ATTACHMENT NO. 8

RRLRT No. W2008-03

**TECHNICAL COMMITTEE:** Railroad and Light Rail Transit Technical Committee

**TOPIC:** MUTCD Proposed Additions to New Manual Chapter 8F (as approved 01/19/2007 by NC)

**Figure 8F-1. Sign and Device Placement on approaches to Pathway-rail grade crossings**

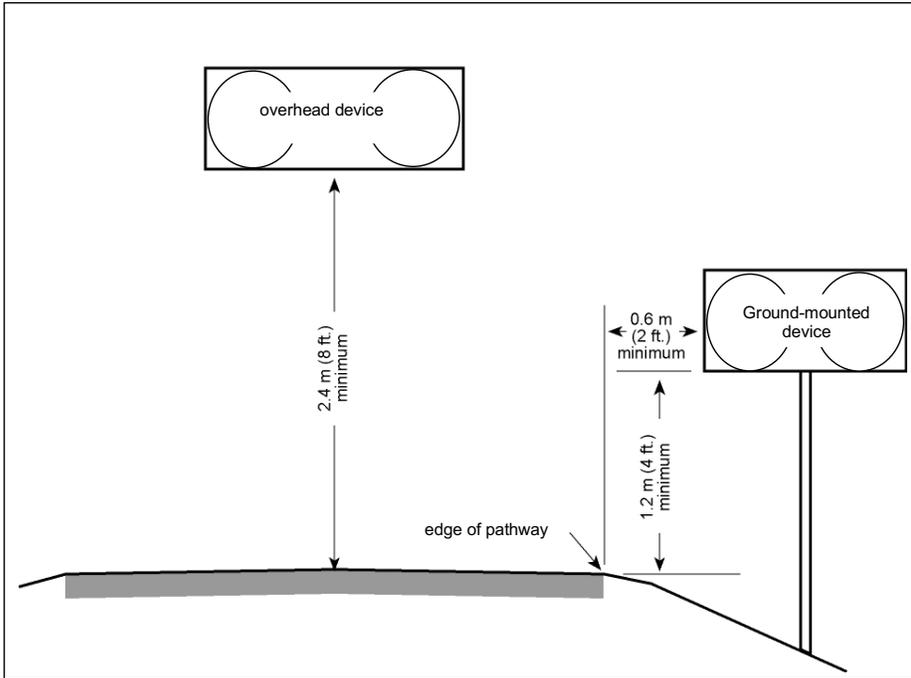
**Traffic control devices mounted on pathways at a height less than 2.4 m (8ft) measured from the bottom edge of the device to the near edge of the pathway surface shall have a minimum lateral clearance of 0.6 m (2 ft) from the near edge of the sign to the near edge of the path (see Figure 8F-1).**

**Mounting height for ground-mounted signs on pathways shall be a minimum of 1.2 m (4 ft), measured from the bottom edge of the sign to the near edge of the pathway surface (see Figure 8F-1).**
